Monthly Specification Update

Intel® Workstation Board S5520SC

Intel Order Number E68106-016

December, 2010

28. Wrong Fan Fault LED may glow if "other chassis" is selected when flashing FRUSDR21

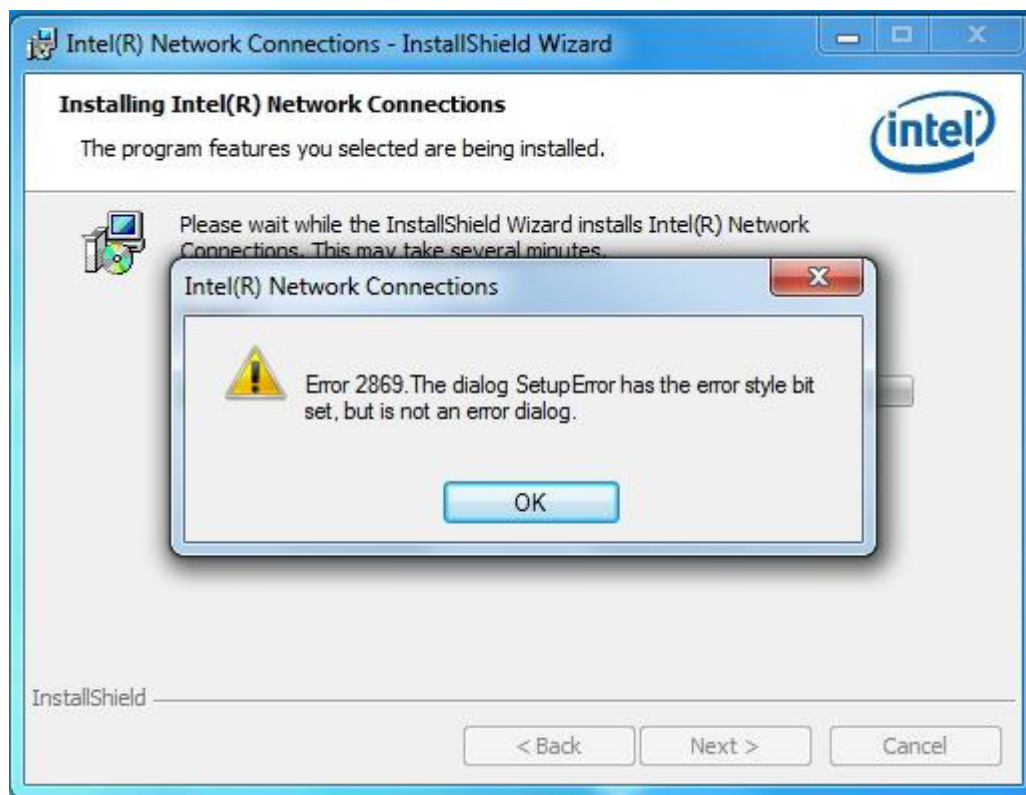
Problem When users update FRUSDR21 and select "other chassis" in the update process, users may see CPU FAN2 Fault LED glow when the upgrade process finishes. This issue occurs only when one CPU is installed in the motherboard.

Implication The unexpected CPU FAN2 Fault LED glowing event is due to a FRUSDR issue, however, there will be no functional impact to the system.

Status This issue is fixed by FRUSDR25.

30. NIC driver 15.1.1 may not be installed properly in Microsoft Windows Vista* or Microsoft Windows 7*

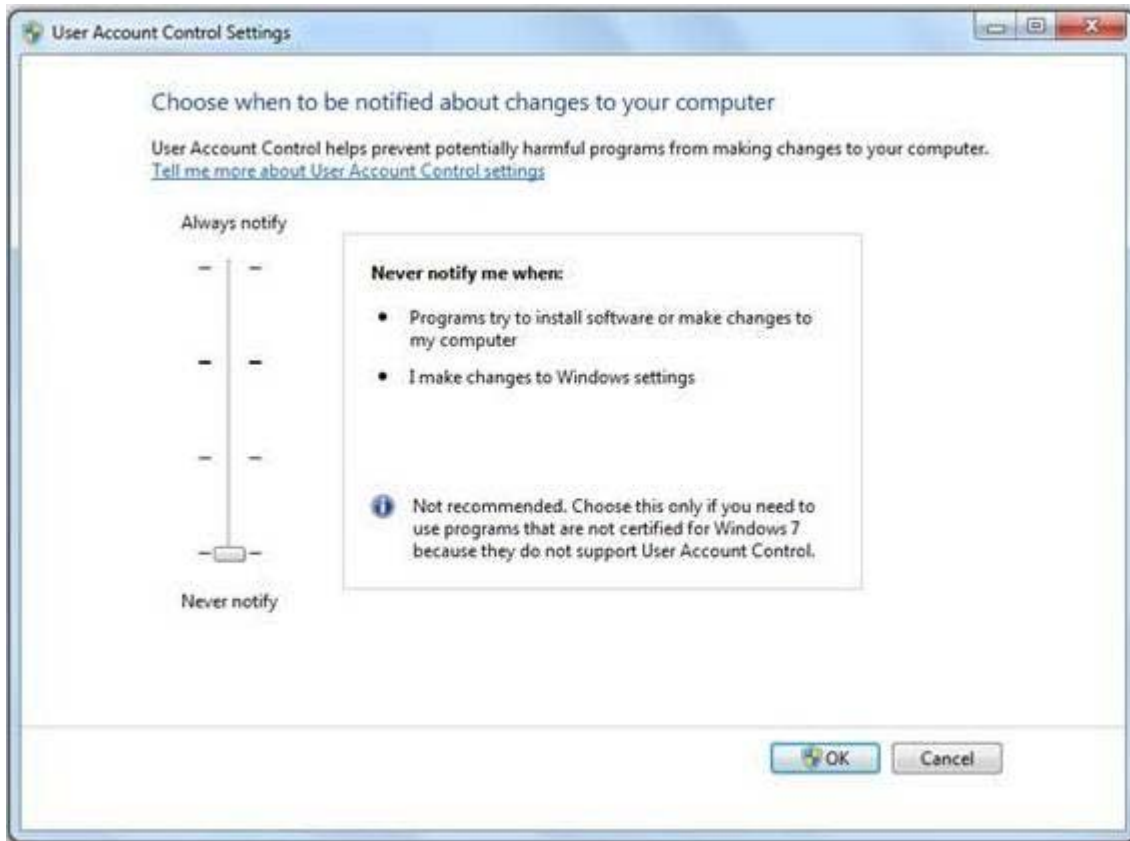
Problem	Users may find onboard NIC (Network Interface Card) driver version 15.1.1 may not get installed properly in Microsoft Windows Vista* or Microsoft Windows 7* when UAC (User Access Control) is set as "Default". Problem may occur during the installation process of the NIC driver, scramble display and unexpected message may display as following:
---------	---

- Implication** This is a permissions issue with Microsoft Windows Vista* and later operating systems. Permissions don't get elevated installing with PROSETDX.MSI, which is the file the batch file in the root directory points to. DXsetup gets the permissions elevated on Microsoft Windows Vista* and later operating systems, but they don't get elevated if you launch the MSI without DXsetup.
- Status** This issue will be fixed by future NIC driver release.
- Workaround** The following workaround can be used to navigate around the issue.
1. Users can browse to the \apps\prosetdx\<os version> directory in the NIC driver package and launch DxSetup.exe.
 2. Users can also refer to below picture to set Windows UAC (User Account Control) to "Never notify", re-install the driver after a system reboot.
